**AMENDMENT 12: Maintenance #15:
Power over Ethernet**

Reference number
ISO/IEC/IEEE 8802-3:2021/Amd.12:2022(E)

Amendment 12: Maintenance #15: Power over Ethernet

Abstract: This amendment implements editorial and technical corrections, refinements, and clarifications to Clause 145, Power over Ethernet, and related portions of the standard. No new features are added by this amendment.

Figure 145–26—Single-signature PD Autoclass state diagram

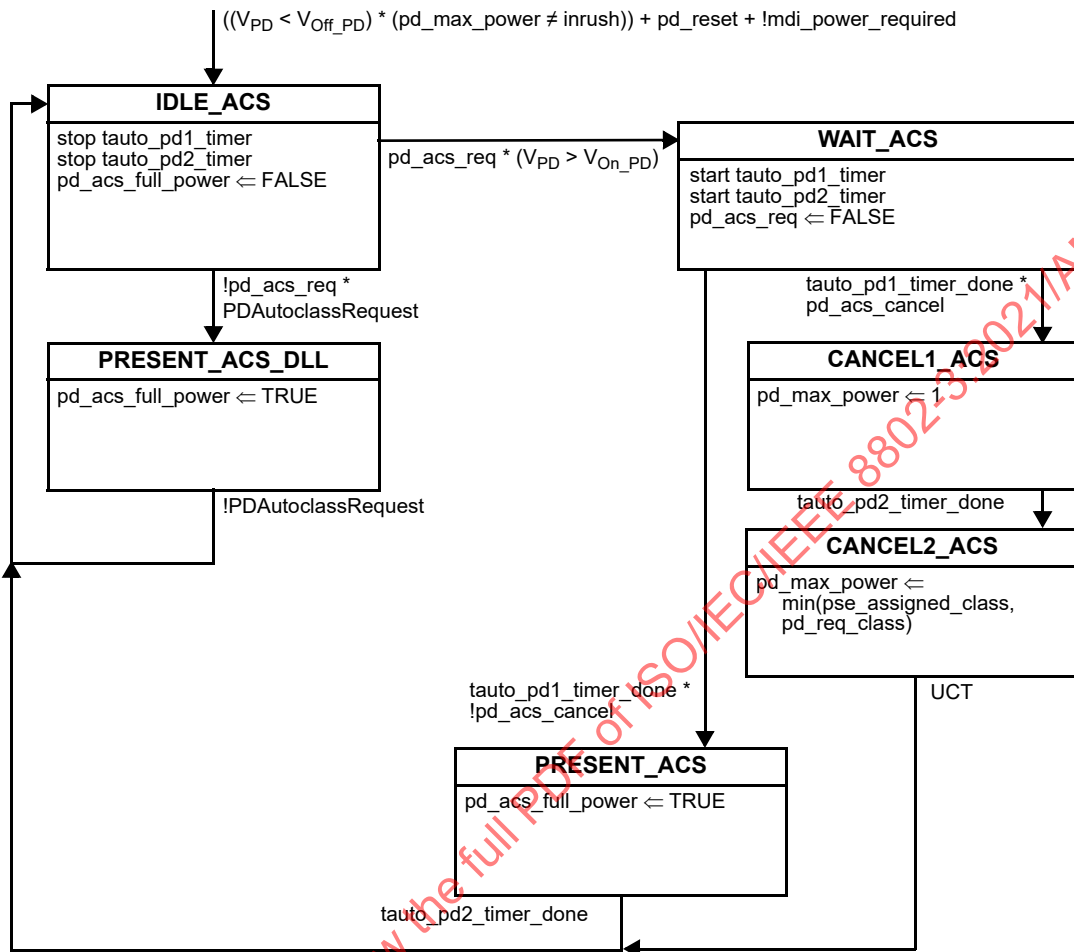
Replace Figure 145–26 with the following:

Figure 145–27—Dual-signature PD state diagram (continued)

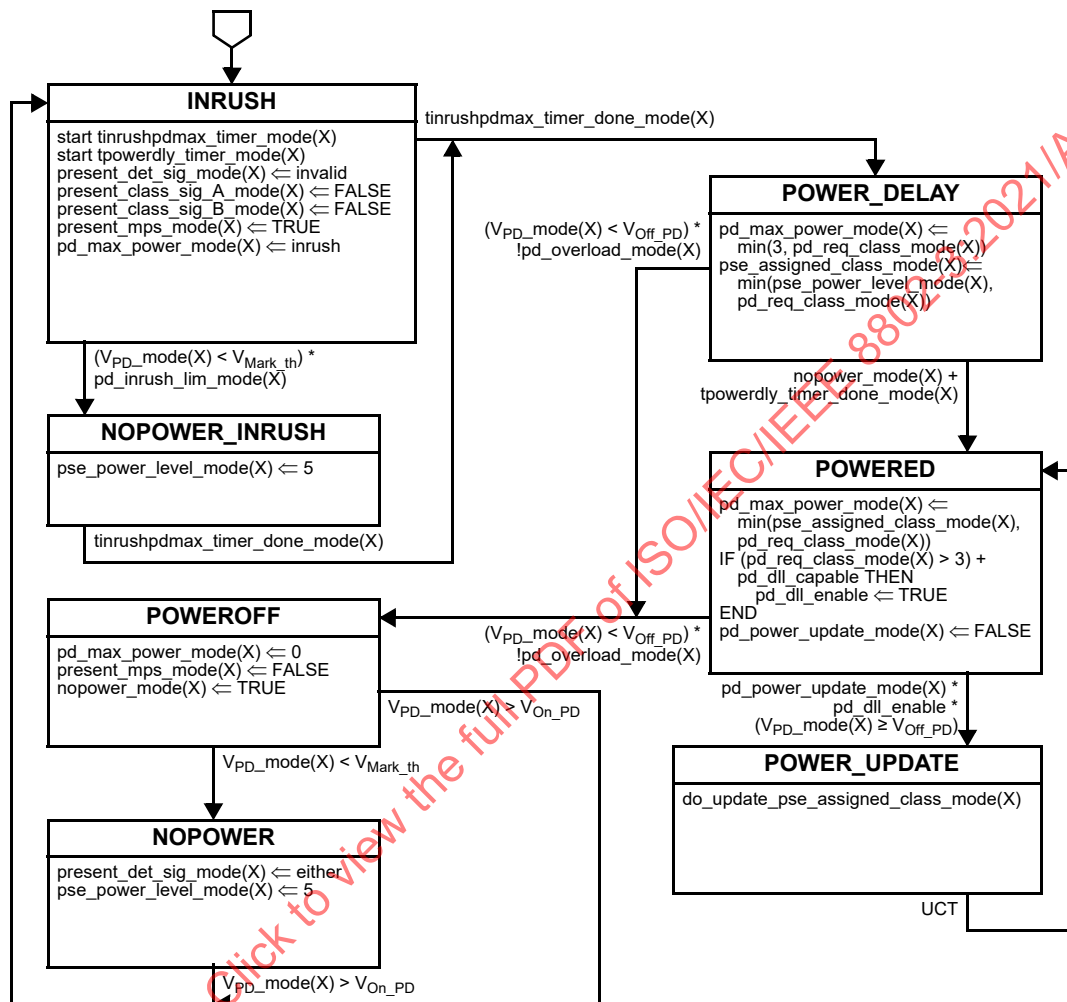
Replace part 2 of Figure 145–27 with the following (with changed content in state POWERED):
